SUBDIVISION AUTHORITY MINUTES MEETING NO. 40

File No. LDA12-0209

RE: Tentative plan of subdivision to create 83 single detached residential lots, 32 semi-detached residential lots, one (1) multiple family lot (MFL) and three (3) Municipal Reserve lots, from the SW 13-15-25 W4M, Lot S, Block 99, Plan 122 5024 and a closed portion of roadway, located north of 41 Avenue SW and east of Charles Link SW; CHAPPELLE

File No. LDA14-0581

LDA12-0209

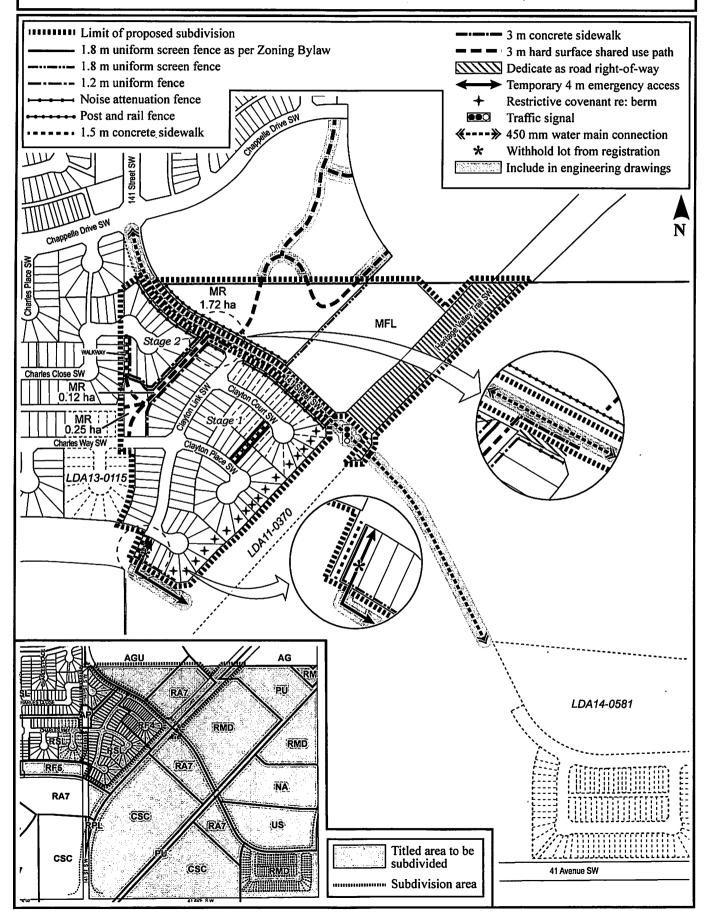
- 1. that the owner dedicate Municipal Reserve (MR) as 0.12 ha, 0.25 ha, and 1.72 ha parcels pursuant to Section 666 of the Municipal Government Act, as shown on the "Conditions of Approval" map, Enclosure I;

- 4. that the owner dedicate an additional 1.5 m road right of way for 141 Street SW to accommodate a 3 m concrete sidewalk, to the satisfaction of Transportation Services, as shown on the "Conditions of Approval" map, Enclosure I;

- 5. that the owner dedicate road right of way to conform to an approved Concept Plan or to the satisfaction of Transportation Services for Heritage Valley Trail SW, as shown on the "Conditions of Approval" map, Enclosure I;

- 6. that subject to Condition I (5) above, the owner clear and level Heritage Valley Trail SW as required for road right-of-way dedication;
- 7. that the lot identified be withheld from registration until the temporary 4 m emergency access is no longer required as deemed by Transportation Services, as shown on the "Conditions of Approval" map, Enclosure I;

- 8. that the owner be permitted to register this plan of subdivision in stages, at the discretion of the Chief Subdivision Officer, having regard to the provision of roadways, MR and the logical extension of services, as shown on the "Conditions of Approval" map, Enclosure I;

- 11. that the approved subdivision LDA14-0581 be registered prior to or concurrent with this application for underground utilities;
- 12. that the owner register a noise attenuation berm restrictive covenant in favour of the City of Edmonton against the lots backing onto Heritage Valley Trail SW, to protect the integrity of the berm, as shown on the "Conditions of Approval" map, Enclosure I; and

- 8. that the engineering drawings include a 450 mm offsite water main connection, to the satisfaction of EPCOR Water Services Inc., as shown on the "Conditions of Approval" map, Enclosure I;

- 9. that the engineering drawings include a 3 m concrete sidewalk, within the boulevard of 141 Street SW, to the satisfaction of Transportation Services, as shown on the "Conditions of Approval" map, Enclosure I;

- that the engineering drawings include and the owner construct a 3 m hard surface shared use path with a dividing yellow centerline, "Shared Use" signage, lighting, and bollards, within the MR lots, to the satisfaction of Transportation Services, as shown on the "Conditions of Approval" map, Enclosure I;

- 11. that the engineering drawings include and the owner construct a temporary 4 m gravel emergency access with T-bollards, to the satisfaction of Transportation Services, as shown on the "Conditions of Approval" map, Enclosure I. This roadway will be required prior to CCC for roads (or when required by Transportation Services);

- 12. that the owner construct a 1.5 m concrete sidewalk with lighting, and bollards, within the walkways, to the satisfaction of Transportation Services, as shown on the "Conditions of Approval" map, Enclosure I;

- 13. that the owner pay for the installation of traffic signals, as shown on the "Conditions of Approval" map, Enclosure I. The City of Edmonton shall complete the signal design, and the City's Electrical Services Contractor must install the signals as per the agreement between the City of Edmonton and the Electrical Services Contractor. The timing of the traffic signals installation will be at the direction of Transportation Services. If traffic signals are not deemed warranted by Transportation Services within 5 years of signing the Servicing Agreement, the owner will be required to provide payment to the City of Edmonton for the installation of traffic signals at that time to fulfill this obligation;

- 14. that the owner construct a noise attenuation fence contained wholly within private property, as per the City of Edmonton Roadway Design Standards Drawing #5205 and in conformance with the submitted noise study, for all lots backing onto or flanking 141 Street SW, to the satisfaction of Transportation Services, as shown on the "Conditions of Approval" map, Enclosure I;

- 15. that the owner construct all fences wholly on privately-owned lands and post and rail on the MR lots, to the satisfaction of Transportation Services and Sustainable Development, as shown on the "Conditions of Approval" map, Enclosure I; and
